SUBJECT: KEWAUNEE NUCLEAR POWER PLANT - ISSUANCE OF AMENDMENT  
(TAC NO. MB7225)

The amendment revises the KNPP operating license and TSs to increase the licensed rated power by 1.4 percent from 1650 megawatts thermal to 1673 megawatts thermal using measurement uncertainty recapture.

SAFETY EVALUATION BY THE OFFICE OF NUCLEAR REACTOR REGULATION  
RELATING TO AMENDMENT NO. 168 TO FACILITY OPERATING LICENSE NO. DPR-43  
NUCLEAR MANAGEMENT COMPANY, LLC  
KEWAUNEE NUCLEAR POWER PLANT  
DOCKET NO. 50-305

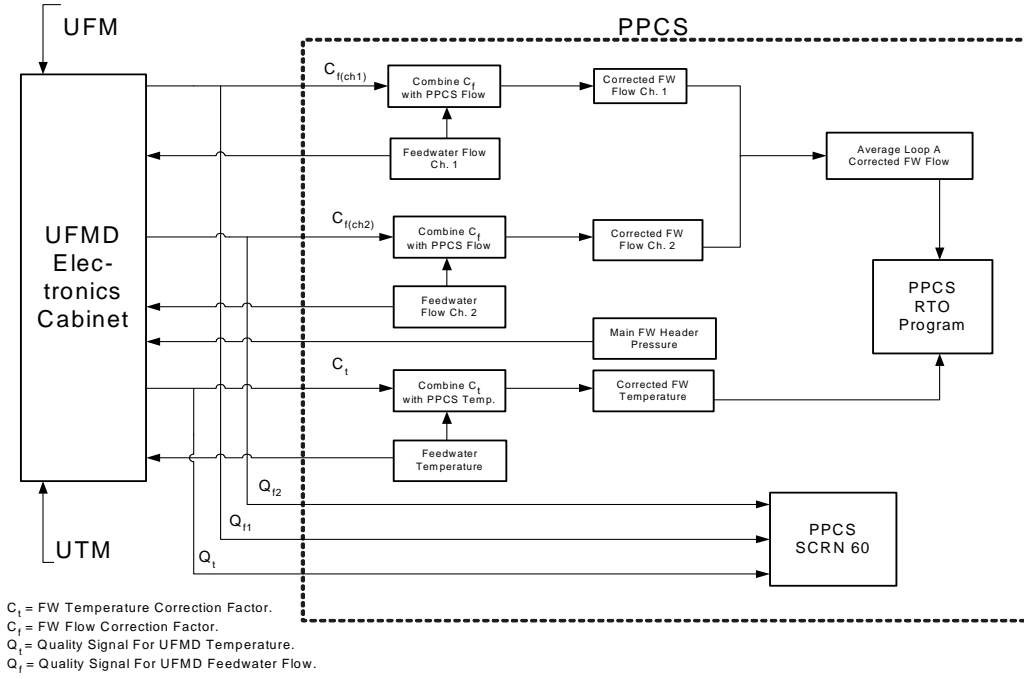
In the licensee's April 30, 2003, letter, NMC provided the figure shown on page 10 for the feedwater alpha or "A" loop data processing and communication links; loop bravo or "B" data processing and communications are identical. This figure was provided as information to facilitate understanding of the system application at KNPP and depicts the integration and operation of the UFMD system and its interface with the plant process computer system (PPCS). The UFMD electronics cabinet takes inputs from the UTM and UFM sensors in each feedwater loop. These sensor signals are processed using the Crossflow software for the UFM's and the CORRTMP software for the UTM's. The UFMD generated values of flow and temperature are compared with existing venturi flowmeters (venturis) and resistance temperature detector (RTD) signals provided from the PPCS to develop instantaneous and average UFMD correction factors,  $C_f$  and  $C_t$ , respectively for the two feedwater flow instrument channels (UFM flow/PPCS flow) and feedwater temperature channel (UTM temp/PPCS temp) in each loop. Quality factors,  $Q_f$  and  $Q_t$ , for each correction factor are generated in the UFMD electronics cabinet by Crossflow and CORRTMP software and sent to the PPCS screen (PPCS SCRIN). The quality factor data is determined and saved with the corresponding correction factor. The UFMD software running in the UFMD electronics cabinet ensures the correction factors are maintained within the required uncertainty. Individual correction factors for feedwater flow and temperature are provided from the UFMD to the PPCS and are used to calculate the corrected feedwater flow and temperature to be used by the PPCS RTO program. The RTO is used for monitoring reactor power such that the operator can control reactor power to less than the licensed limit.

The KNPP Crossflow UFM was calibrated according to the topical report CENPD-397-P-A, Revision 1 dated May 2000. A UFM in feedwater loop "A" is installed where the flow is fully developed. As such, this UFM does not need calibration. The UFM in feedwater loop "B" is installed where the flow is not fully developed and thus needed a one-time in-situ calibration. For this calibration, a temporary stand-alone UFMD was installed on the full flow feedwater bypass line. The temporary UFM was installed at a location in the bypass line meeting the conditions for fully developed flow and was used for the UFM "B" calibration.

The NRC staff finds that the licensee's response to the plant-specific requirements stated in the NRC's safety evaluation for topical report CENPD-397 were appropriately addressed and are acceptable.
